**Economic and Social Council**Distr.: General
15 June 2023

World Forum for Harmonization of Vehicle Regulations**Working Party on Noise and Tyres****Seventy-eighth session**

Tyres: UN Regulation No. 117 (Tyre rolling resistance, rolling noise and wet grip)**Proposal for Supplement 2 to the 04 series of amendments to
UN Regulation No. 117****Submitted by the Informal Working Group on Measurement
Uncertainties***

Figure 1
Minimum requirements for test surface area. The shaded part is called "Test area"

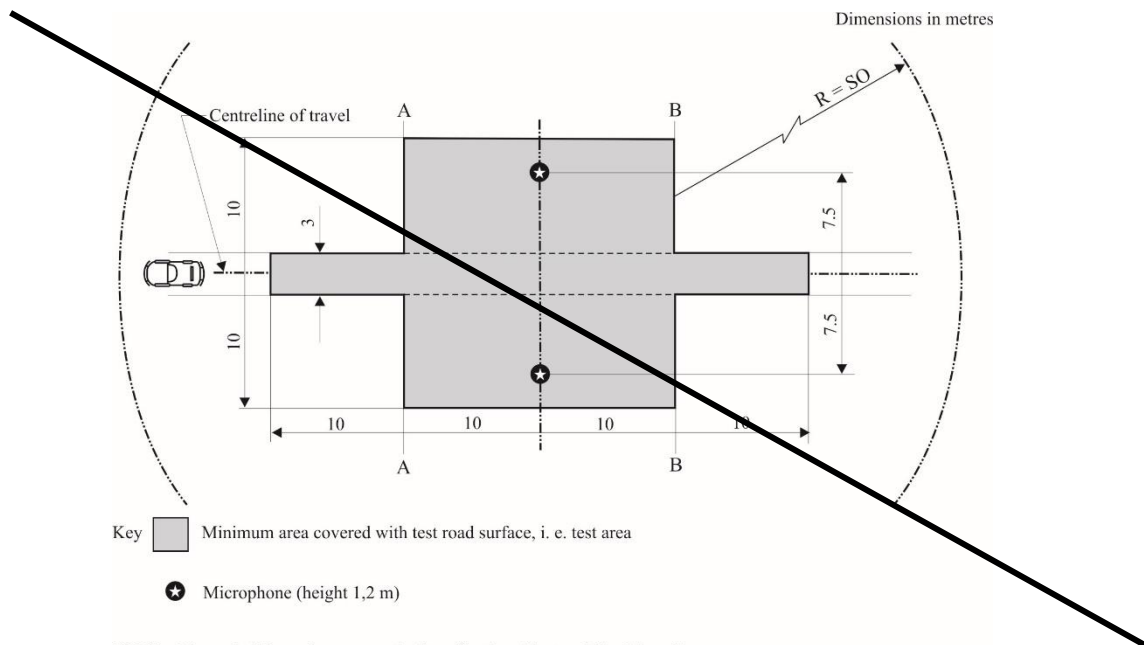
Annex 4, amend to read:

~~Reserved Specifications for the test site[†]~~

6. The content of Annex 4 was removed, references to it were deleted, as well as the one to paragraph 12.8. whose current content has changed and does not have anything to do with Annex 4. A blank Annex 4 is kept and reserved for future utilisation.
